DEPARTMENT OF TRANSPORTATION**Federal Aviation Administration****14 CFR Part 39**

[Docket No. 2002–SW–22–AD; Amendment 39–12835; AD 2002–08–54]

Airworthiness Directives; Bell Helicopter Textron Canada Model 222, 222B, 222U, and 230 Helicopters

ACTION: Final rule; request for comments.

Figure 1

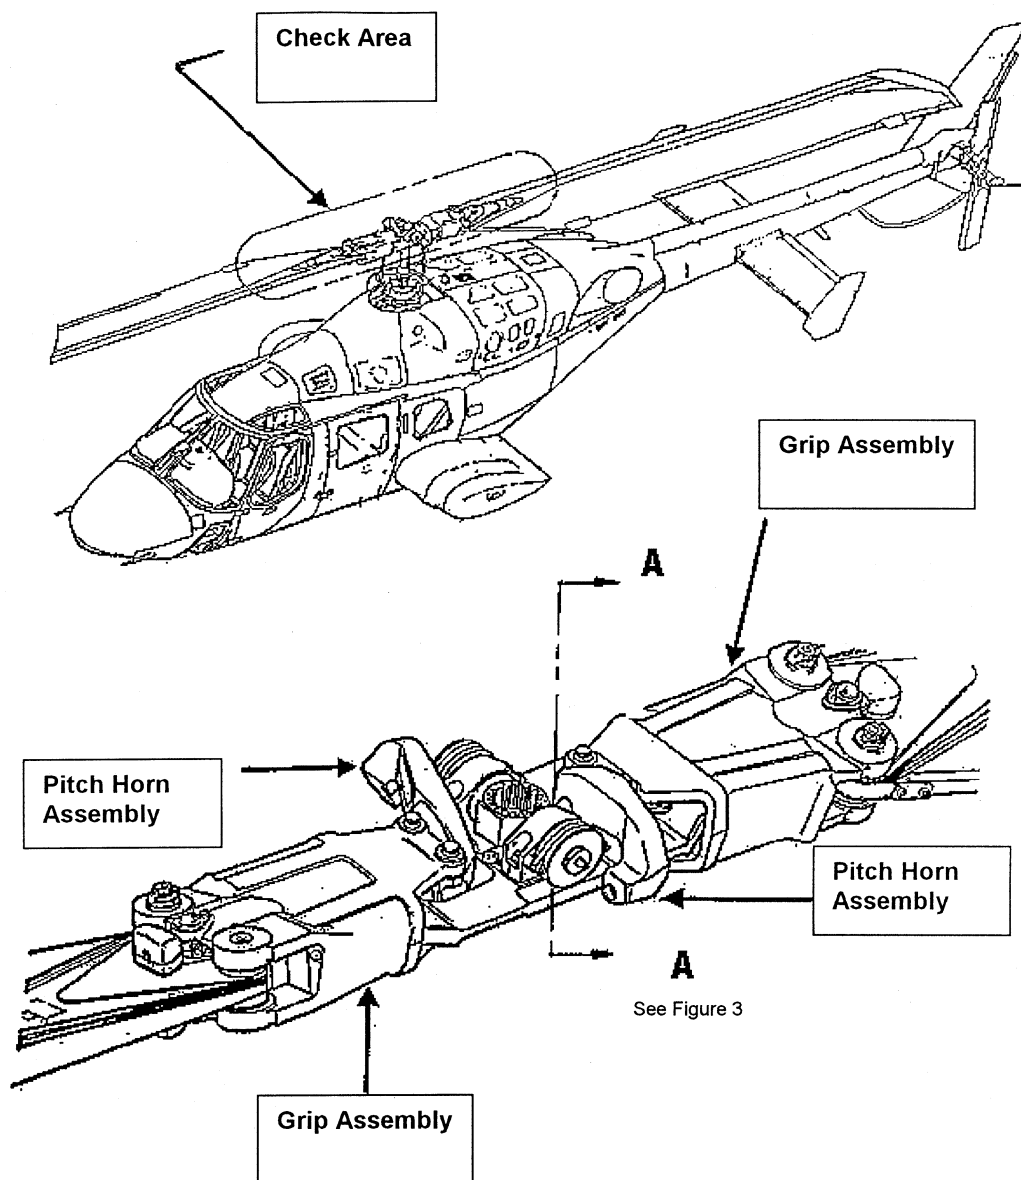
(1) Wipe clean the main rotor grip and pitch horn surfaces to remove grease and dirt in the check area as shown in Figure 1 of this AD:

Figure 2

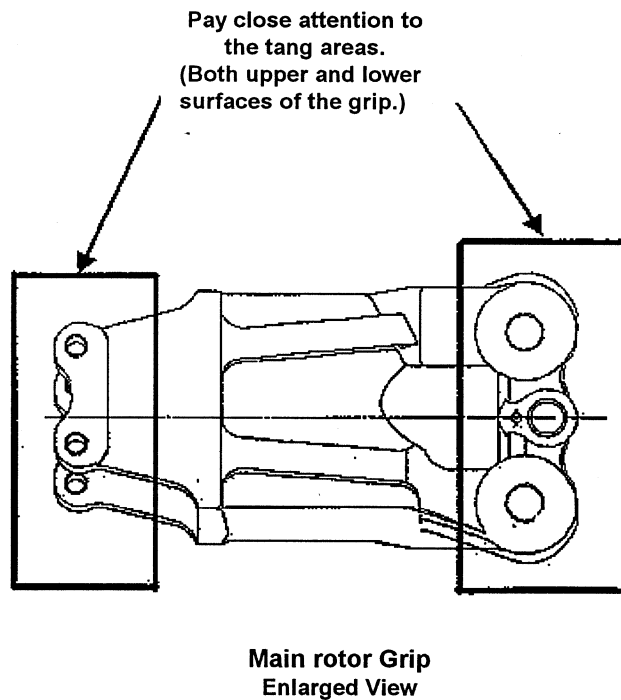
(2) Visually check both main rotor grips for a crack, paying particular attention to the inboard and outboard tangs/portions of the grip, which are in direct contact with the pitch horns and the main rotor blades. Check the area to at least 3 inches beyond the grip/pitch and grip/blade contact areas as shown in Figure 2 of this AD:

Check entire surface of the grip.

Figure 3

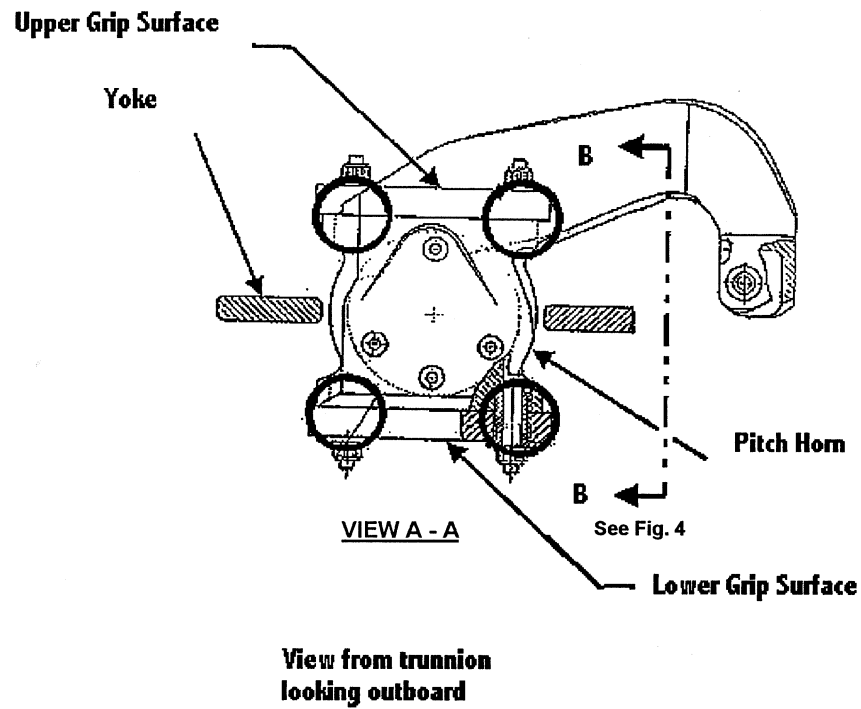
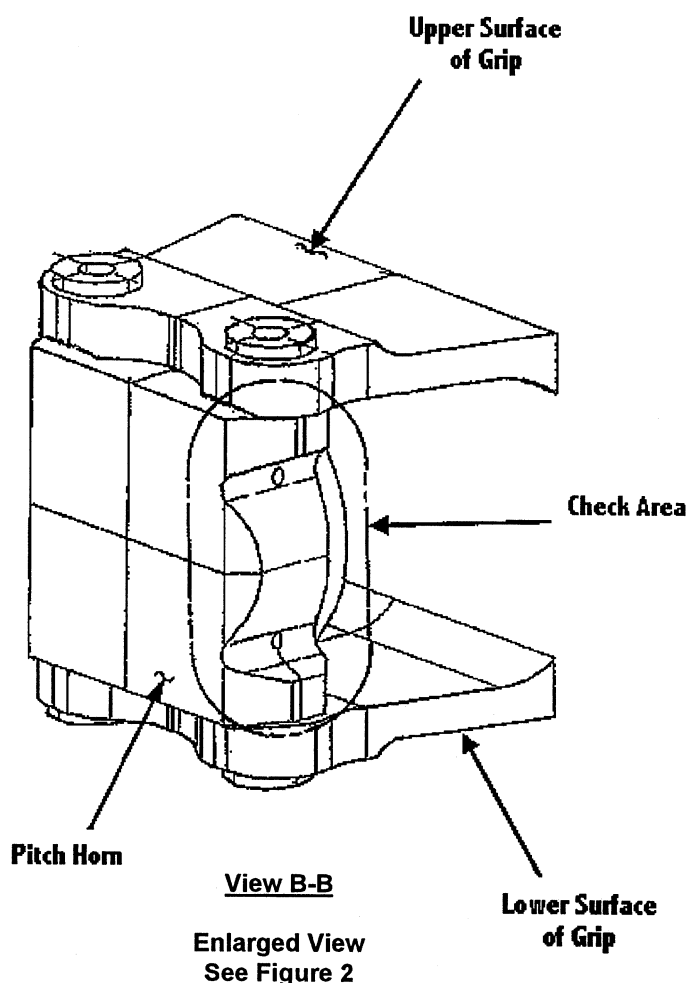
(3) Visually check all visible portions of each pitch horn for a crack. Pay particular attention to the attachment lugs of the pitch horns, which are in direct contact with the inboard tangs of the main rotor grips, as shown in Figure 3 of this AD, and the four large bolt cutouts, as shown in Figure 4 of this AD:

**All visible portions of the pitch horn must be checked.
Pay particular attention to the circled areas shown above and View B-B, Fig. 4.**
